340 – 350 FREMONT STREET

Final Environmental Impact Report

Planning Department Case No. 2004.0552E

Visual Simulation:
View Looking East on the Bay Bridge Ramp

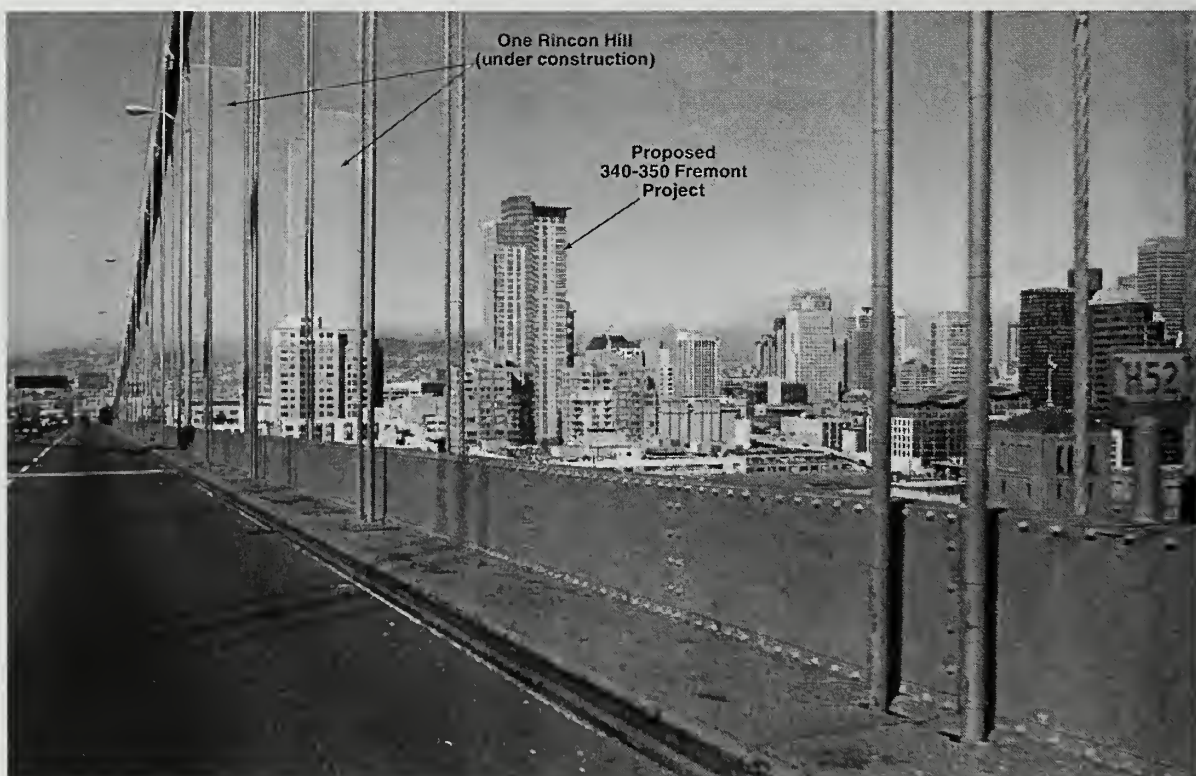
In addition to requesting photos which show ALL of the proposed or approved buildings, I request that the photos be LEGIBLE. To understand visual impacts THE RENDERING NEED TO BE UNDERSTANDABLE. I specifically direct your attention to Figure 16 on page 49. The One Rincon Hill project is virtually invisible!!! The QUALITY of the photos - both from the Bridge and to the Bridge from the central part of the City – is such that no one will be able to UNDERSTAND the loss of visual connection from the Bay Bridge to Twin Peaks. When visual issues are so important, even if the developer doesn’t want to pay for high quality renderings in the EIR, he MUST provide them and MEA must require them. The renderings that they supply for project approval are not this shabby. The EIR is a PUBLIC INFORMATION DOCUMENT. These photos, as they are reproduced in the DEIR are junk and seem to intentionally distort and downplay visual impacts.

simulations, the Planning Department's Major Environmental Analysis unit has consistently and for many years presented the same type of information as is included in this DEIR: visual simulations that show both pedestrian (close-up) and longer-range perspectives. Accordingly, the simulations of the proposed project on pp. 46 and 47 (Figures 13 and 14), which are from pedestrian (i.e., close in) viewpoints, do not depict the entire building because to do so would distort the photograph. On the other hand, Figures 12, 15, and 16 (pp. 45, 48, and 49) do depict the entire building, as the photographs used in those simulations are taken from vantage points farther from the project site.
